## **REMARKS**

Applicant submits this Preliminary Amendment in order to correct certain inconsistencies between the Specification and Figures.

**AMENDMENTS TO THE DRAWINGS:**

**FIG. 5**

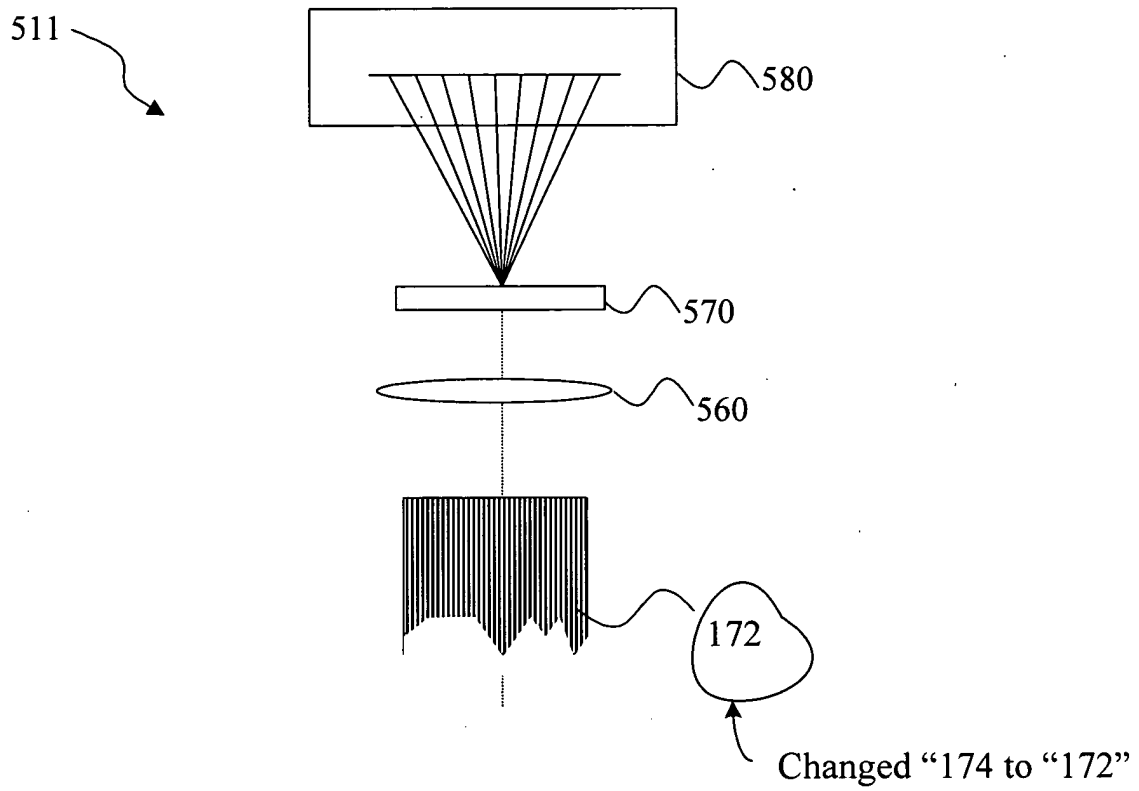
Fig.5 has been corrected by relabeling item 174 as item 172. Item 174 is defined as an “illumination bundle”, and item 172 is defined as a “sensor bundle”. Specification, p.13, ln.4. In the text corresponding to Fig.5, “light reflects off the wafer and is received by sensor bundle 172, which couples the light to lens assembly 560 ....” Specification, p.21, ln.22-23. Thus, the amendment to Fig.5 makes the drawing consistent with the specification.

The attached drawing sheets include changes to Fig.5, Fig.7B, Fig.7C, Fig.13 and Fig.16. The change to Fig.5 consists of relabeling item 174 as 172. The change to Fig.7B and the change to Fig.7C each consists of relabeling item 620' as 620. The changes to Fig.13 consist of relocating label 180, adding label 1330, and relabeling item 1360 as 1355. The changes to Fig.16 consists of relabeling items 750, 760, 770 and 780 as items 1650, 560, 570, and 580, respectively.

**FIGS. 7 (A) - (C)**

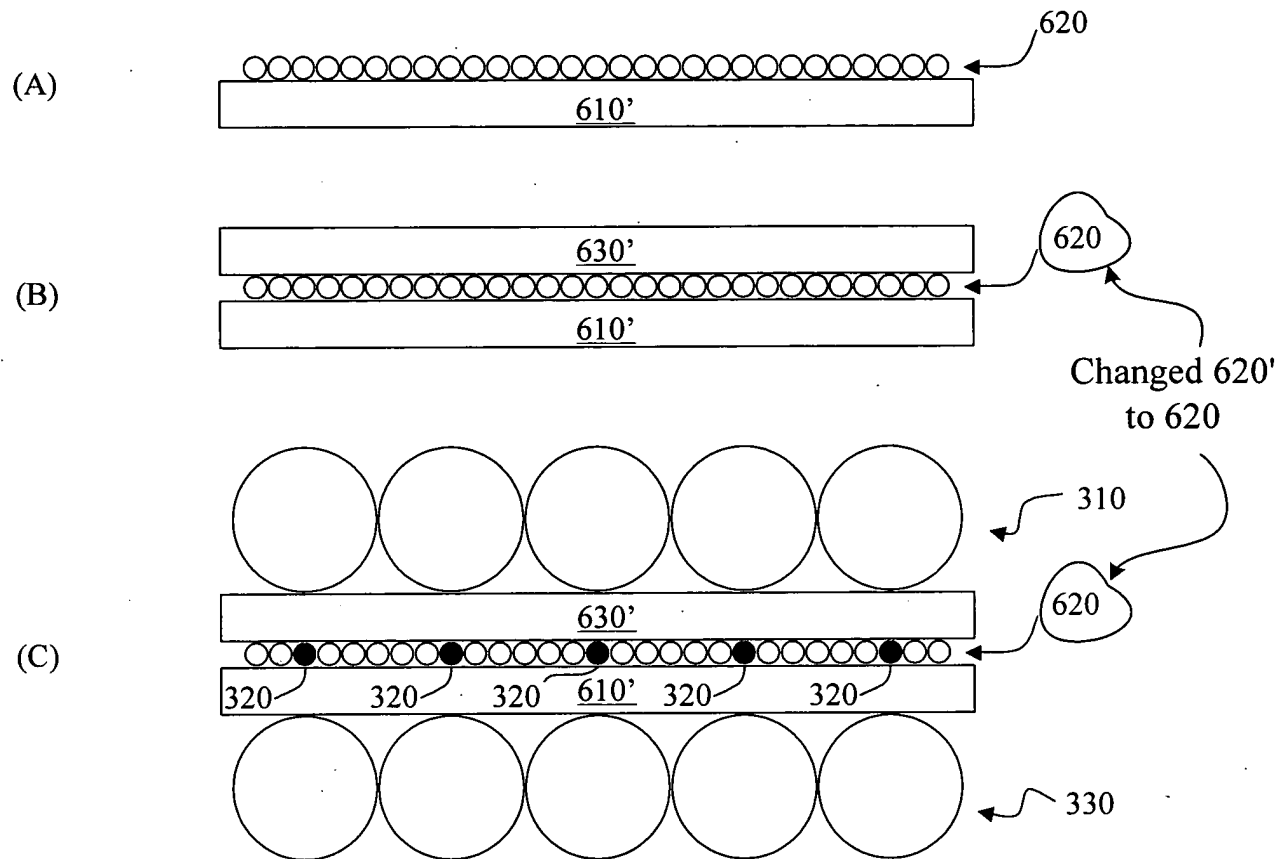
Fig.7B and Fig.7C have been corrected by relabeling item 620’ as item 620, in each figure. This makes the figures consistent with the Specification at p.23.

**FIG. 16**

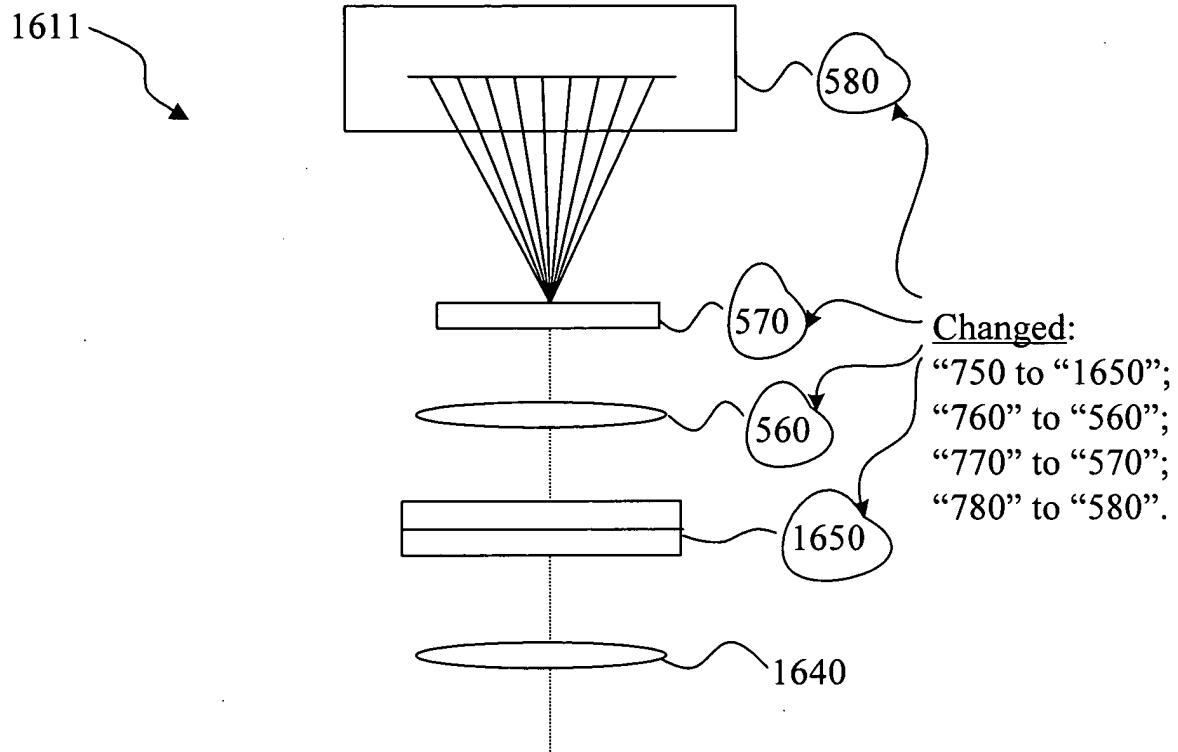
Fig.16 has been corrected by relabeling items 750, 760, 770 and 780 as items 1650, 560, 570, and 580, respectively. Identifying numerals 750, 760, 770 and 780 do not appear in the Specification. Thus, the “slit” which is clearly shown as item 750 in Fig.16 has been relabeled as item 1650. In addition, the “lens assembly”, “diffraction grating” and “imager” clearly shown as items 760, 770, and 780, respectively, on Fig.16, have been relabeled as items 560, 570, and 580, respectively. This labeling is consistent with labeling of similar components shown in Fig.5.

Finally, the Specification has been amended by rewriting the paragraph beginning on p.36 at ln.8 for consistency in view of the drawing amendments to Fig.16, to improve readability, and to correct grammatical errors. The paragraph has also been amended to describe items 1640 and 1650 originally shown but not described in Fig.16. Thus, no new matter is introduced by this or any of the above amendments.
